# AEBS-HDV IWG Input from industry

AEBS-HDV-05

June 30 and July 1, 2021

## Pre-filling of brakes

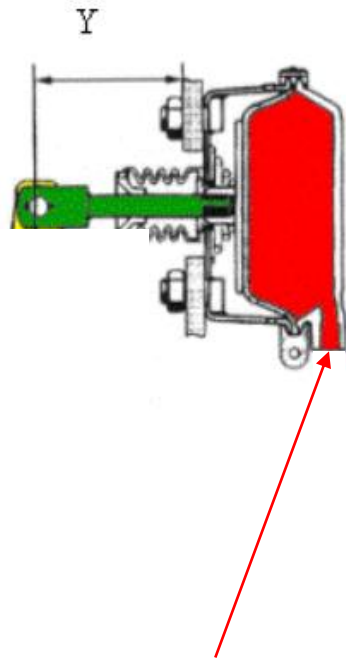
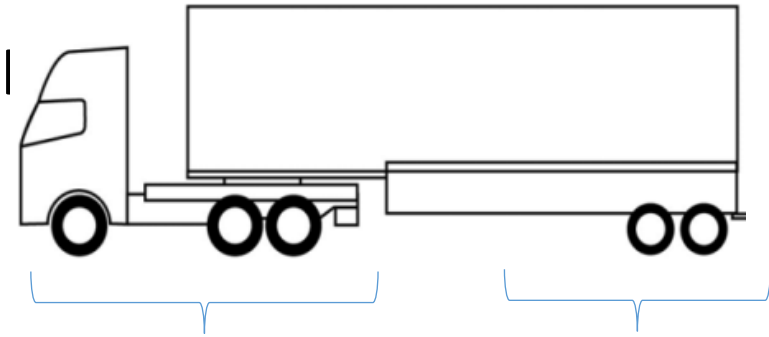
Pre-filling of the pipe between brake valve and cylinder would not reduce the delay significantly

Pre-filling of cylinder would create a risk that the pads leak the disc  
→ this may create **functional safety issues**

- This typically creates a Jack-knifing risk
- Prefilling trailer brakes may solve this, but the truck cannot “blindly” pre-fill the trailer brakes (without knowing the threshold pressures of the actual trailer being towed)

- **Industry does not look at brakes pre-filling as a potential solution**
- **The additional brake delay of pneumatic braking is there, and we have to account for it in the AEBS strategy, as proposed in AEBS-HDV-04-04**

## 5.2.1.4. Speed reduction by braking demand

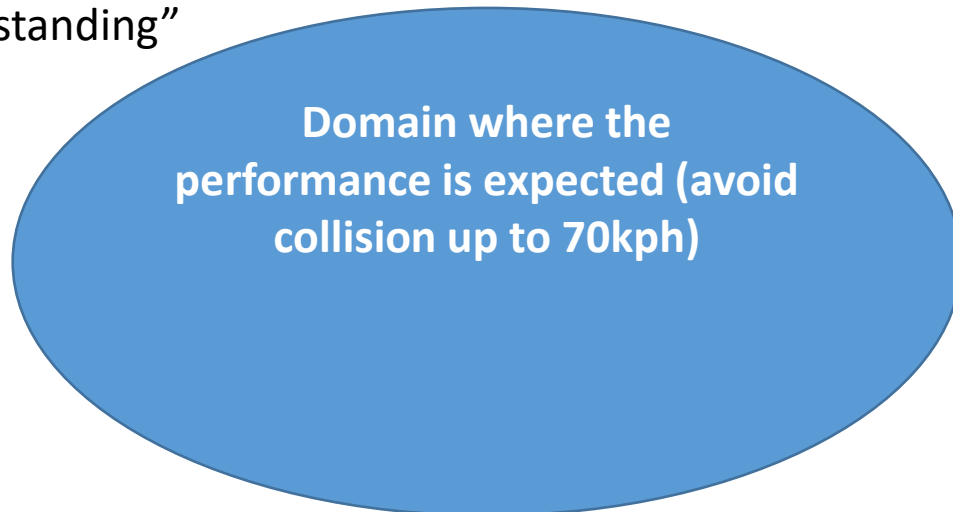
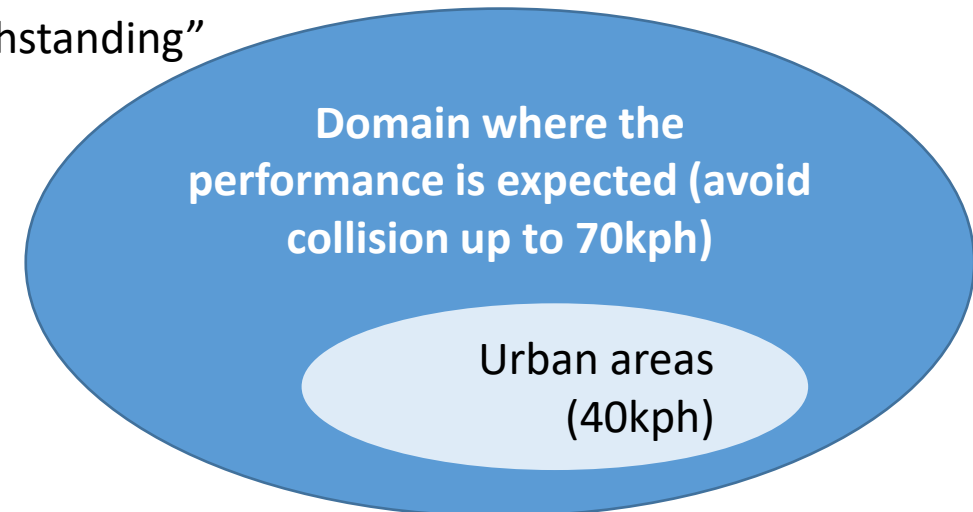
**Notwithstanding the table above, for those vehicle able to detect urban areas where the speed is limited to 60kph or below, the speed reduction shall not be lower than 40 kph, for actual vehicle speed between 10 and 60kph. In this case, the means used by the vehicle to detect the urban areas as specified above shall be described by the vehicle manufacturer, and the safety concept assessed by the Technical Service according to Annex 3 of this regulation.**

Without  
“notwithstanding”

With  
“notwithstanding”

## 5.2.1.4. Speed reduction by braking demand

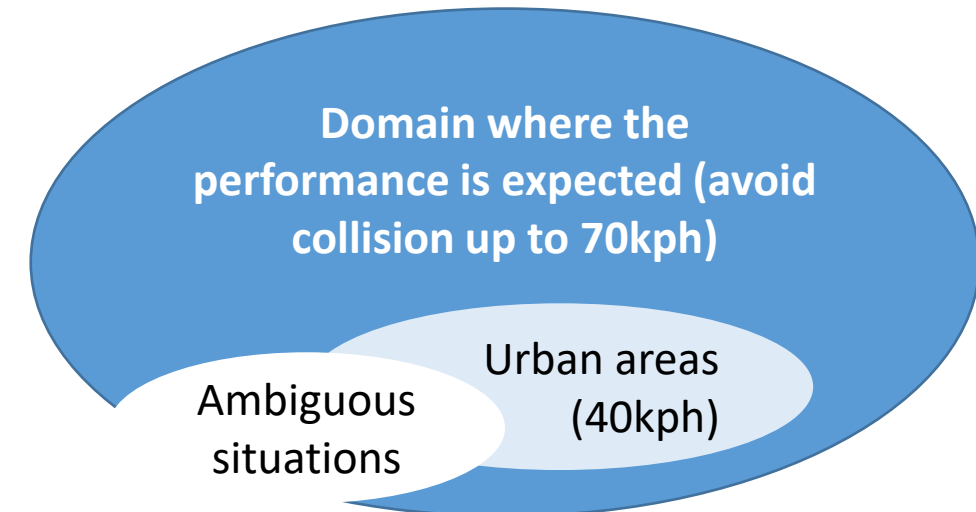
- (h) **In unambiguous situations (e.g. no motorcycle nor bicycle in between rows of vehicles, no laterally waving vehicle in the adjacent lanes)**

**Notwithstanding the table above, for those vehicle able to detect urban areas where the speed is limited to 60kph or below, the speed reduction shall not be lower than 40 kph, for actual vehicle speed between 10 and 60kph. In this case, the means used by the vehicle to detect the urban areas as specified above shall be described by the vehicle manufacturer, and the safety concept assessed by the Technical Service according to Annex 3 of this regulation.**

**We need both...**

With both (h) and "notwithstanding"

# Vehicle longitudinal centre planes (offset)

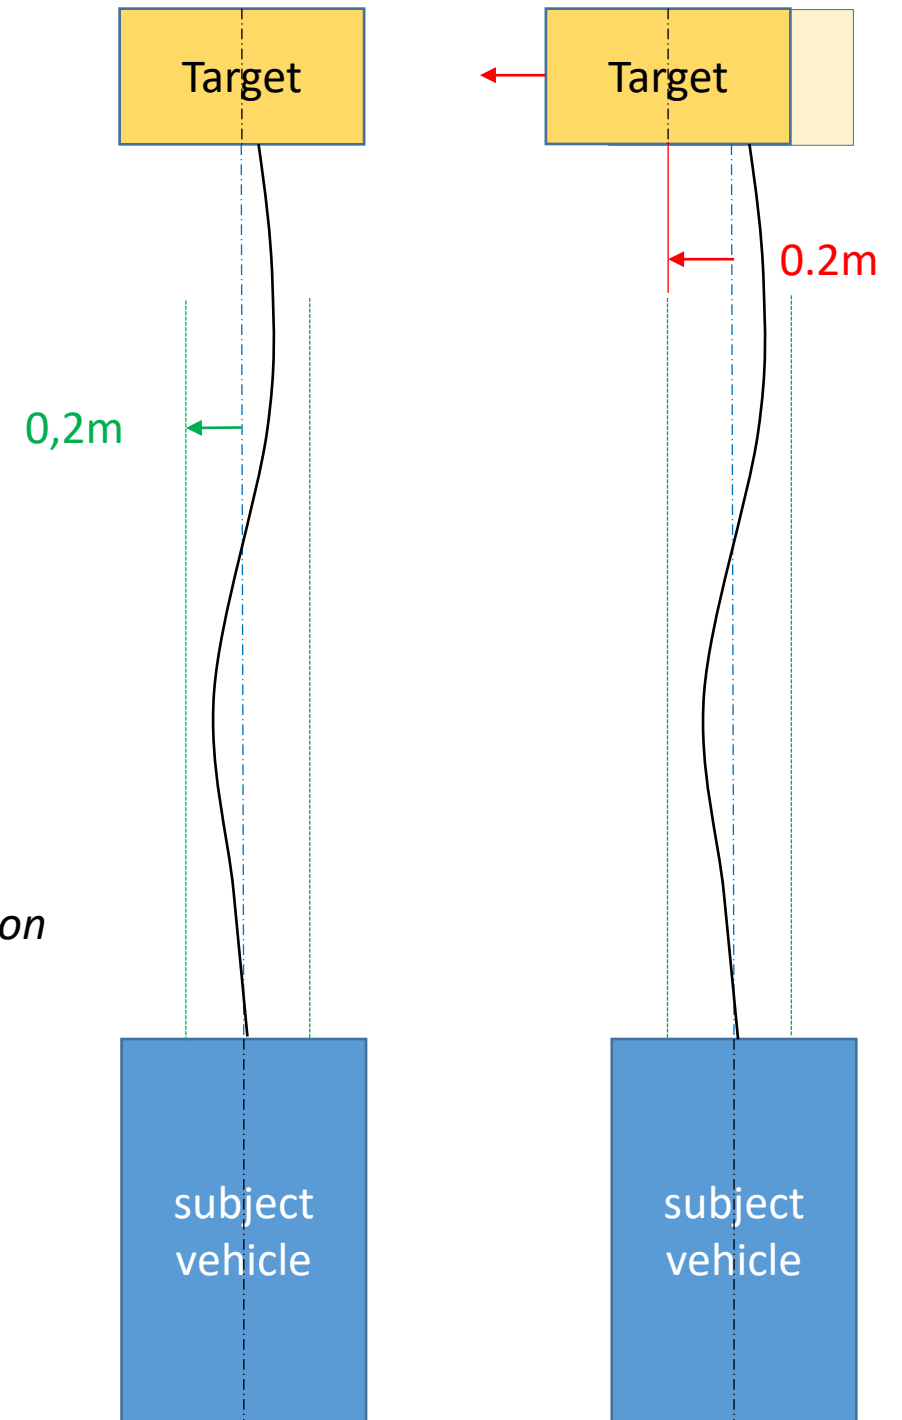
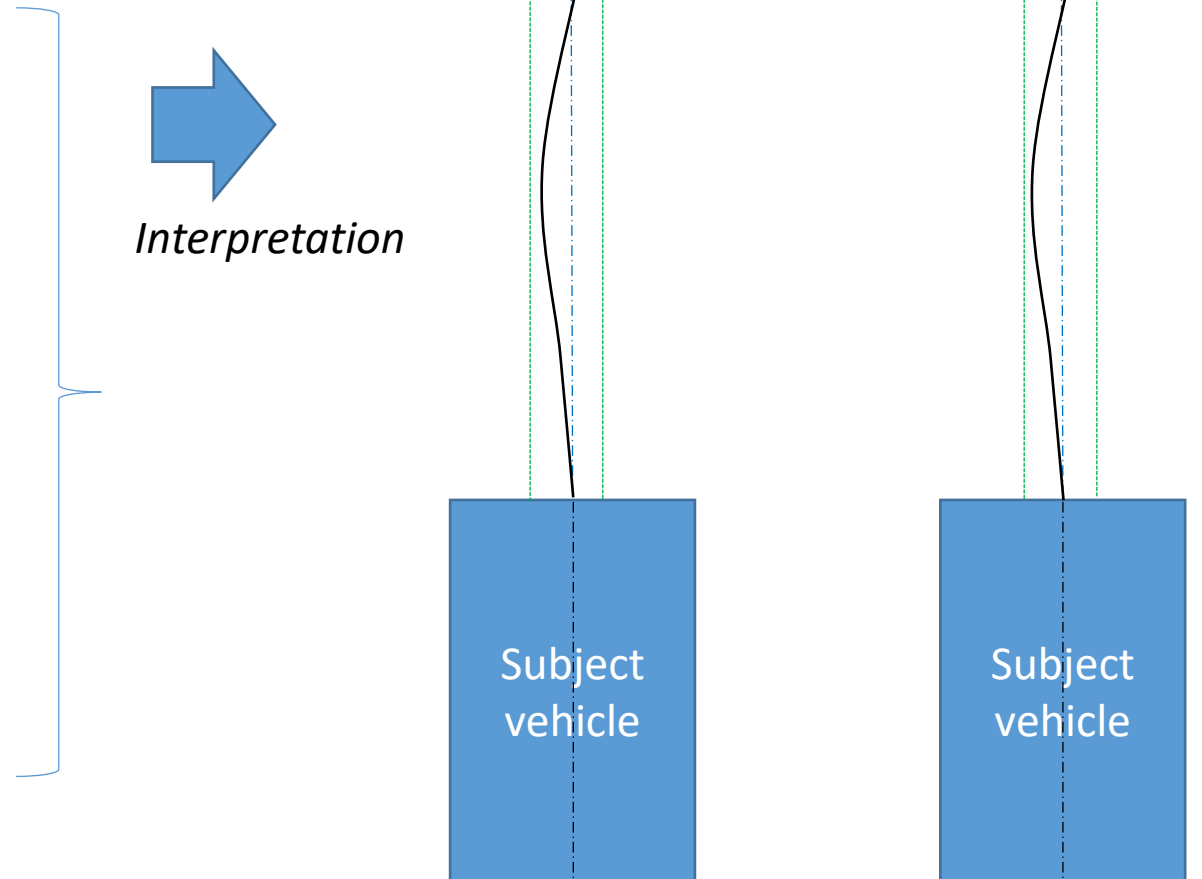
- (d) In situations where the vehicle longitudinal centre planes are displaced by not more than 0.2 m;

*It may be understood that each centre plane (the one of the target vehicle and the one of the subject) should be displaced (in opposite directions, that would mean +/-0.4m)*

- (d) In situations where the **target—vehicle** longitudinal centre planes **are—is** displaced by not more than 0.2 m **compared to the subject vehicle longitudinal center plane;**

- 6.5 The subject vehicle and the moving target shall travel in a straight line, in the same direction, for at least two seconds prior to the functional part of the test. with a subject vehicle to target centreline offset of **not more than 0.2m.**

# Follow shark fin curve up to 110

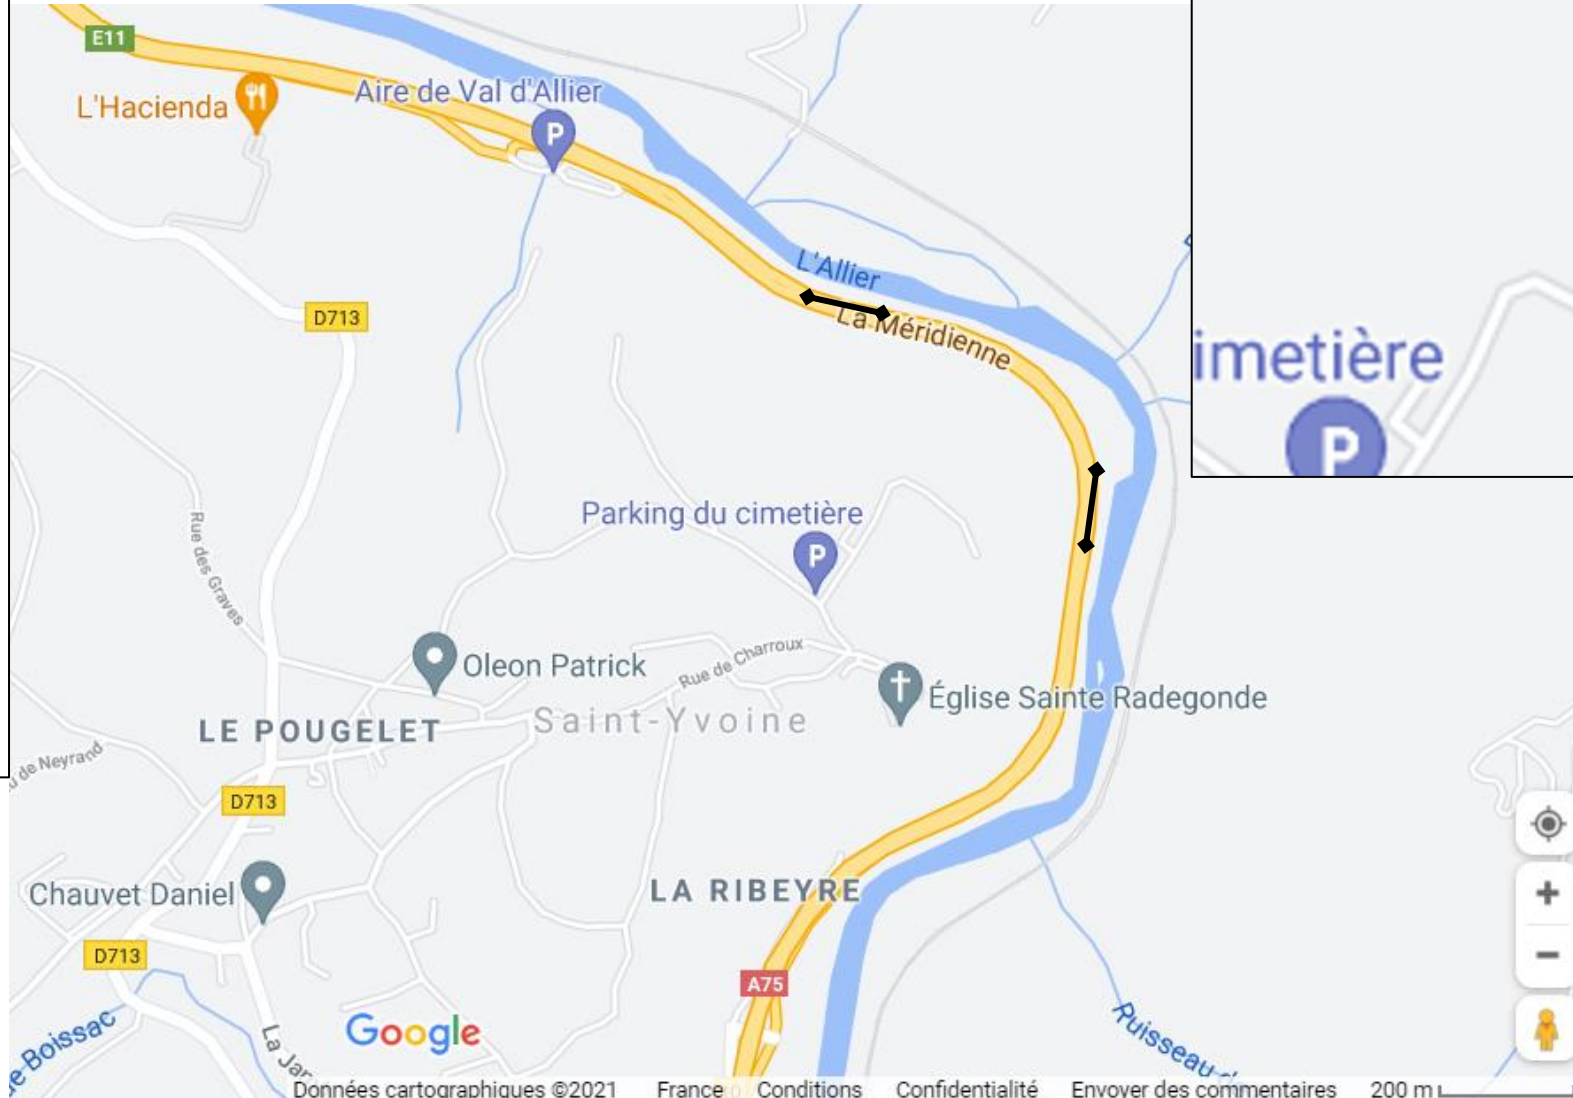
Motorway  
E11 / A75,  
Speed limit  
110kph.

Required  
sensor range  
(to warn and  
brake in time):  
110m.

At such speed and distance, there is a risk to for example detect a vehicle on the hard shoulder as being on the ego lane.

Recommendation to limit the requirements at 100kph.

## N3/N2 and M3/M2

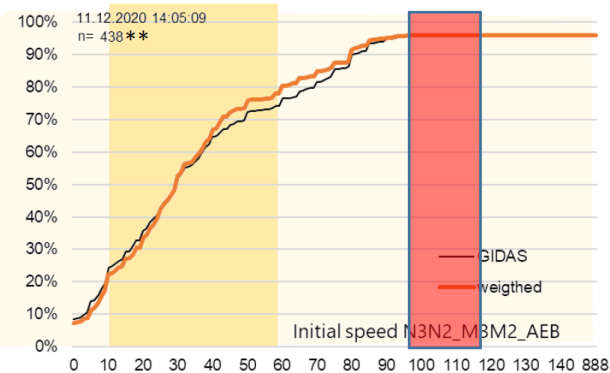
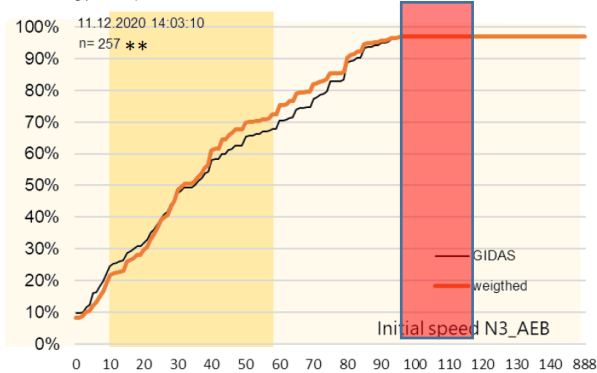
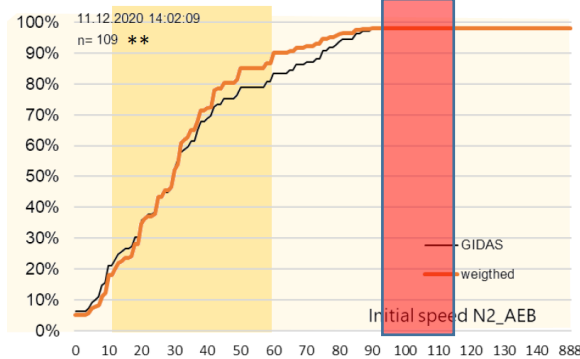
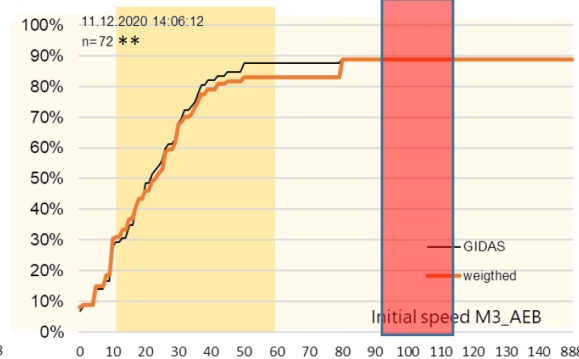
**Based on the accident analysis (AEBS-HDV-SP-02-05) there is no need to enlarge the speed range mandatory to 110 kph  
=> Keep current draft AEBS-HDV-04-08 as it is (100 kph)**

# Safety zone for HDVs in „real life“ conditions

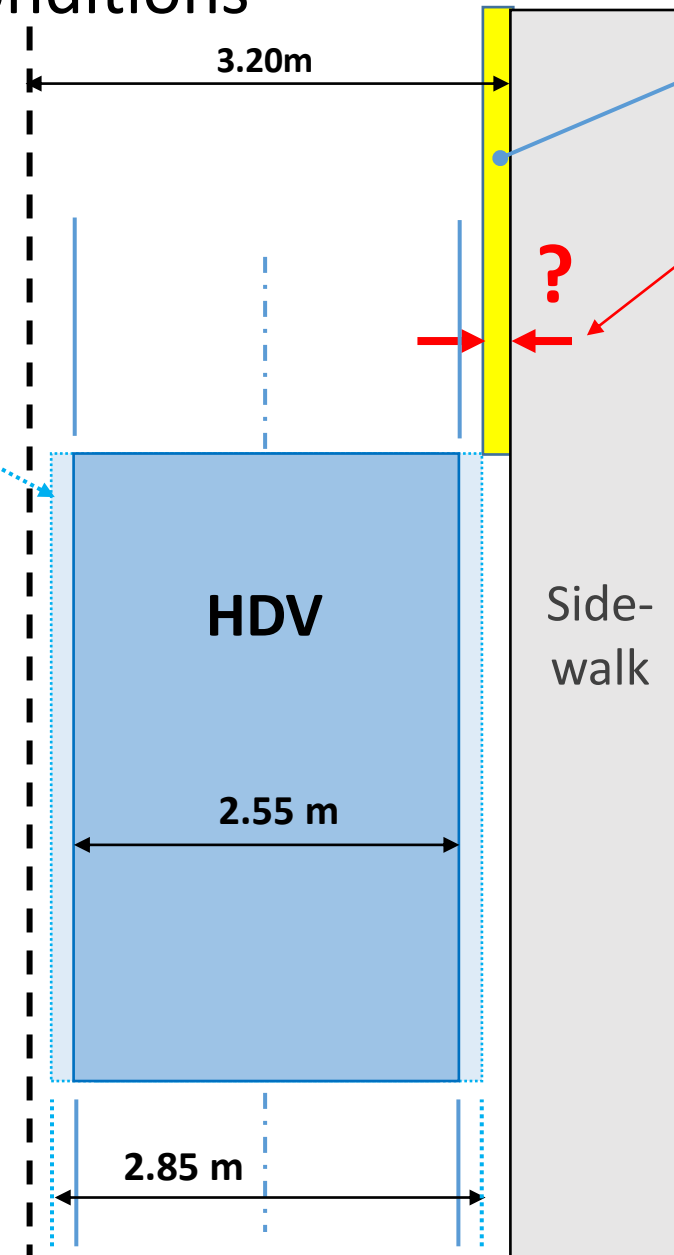
In general, it should be avoided to brake on pedestrian on the sidewalk (to limit the risks of false positive).

- HDVs are wider than passenger cars, thus are driving closer to the sidewalk, which is **increasing the risk of getting false positives**.

- A vehicle cannot be driven 100% in the center of the lane. Small drifts with e.g. +/- 15cm or 20cm to both sides are normal for a HDV. (Reminder: R131 specifies a „target centreline offset of **not more than 0.5 m**“, in test section 6.4.1).
- Lanes in urban areas are often narrower than the 3.5m considered during the M1N1 discussions (3m or 3.30m are more common).
- A lot of roads in urban areas don't have lane markings in the middle (leading to some tendency to drive closer to the sidewalk).

HDVs safety zone should not be more than 10 or 20 cm

#### 5.2.1.4. Speed reduction by braking demand

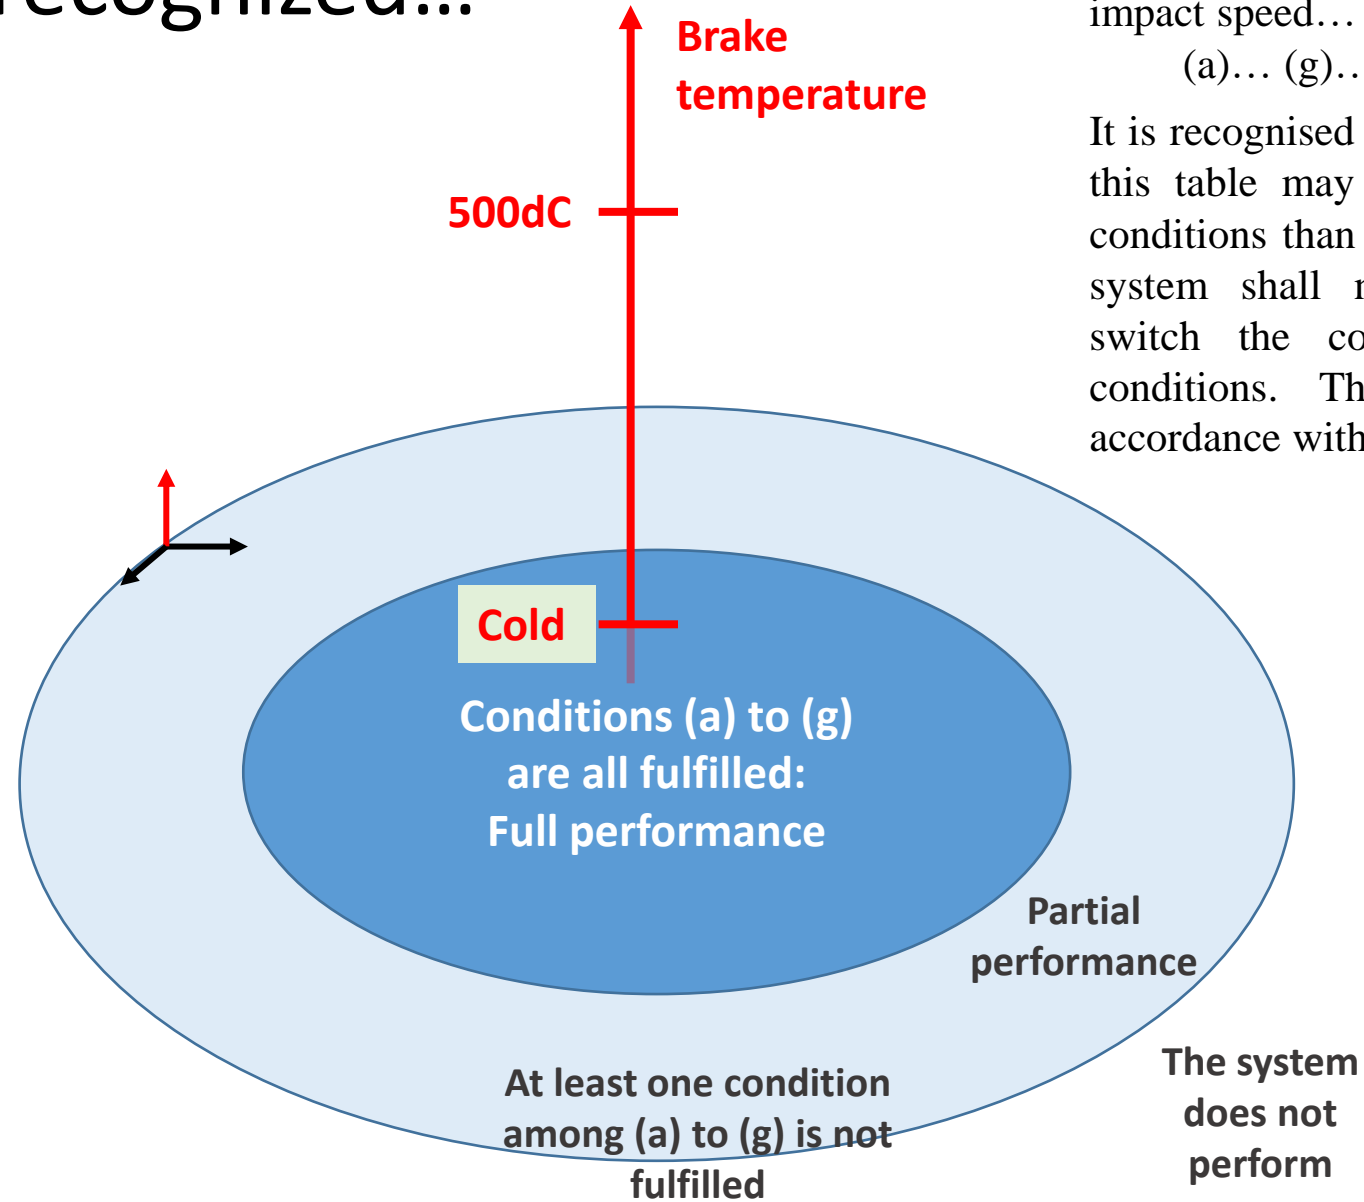
The issue is that some conditions are not named in the list (a) to (g);

Thus, it could be interpreted that the full performance is expected whatever status these conditions have (e.g. hot brakes), provided conditions (a) to (g) are all fulfilled... which is obviously not the original intention...
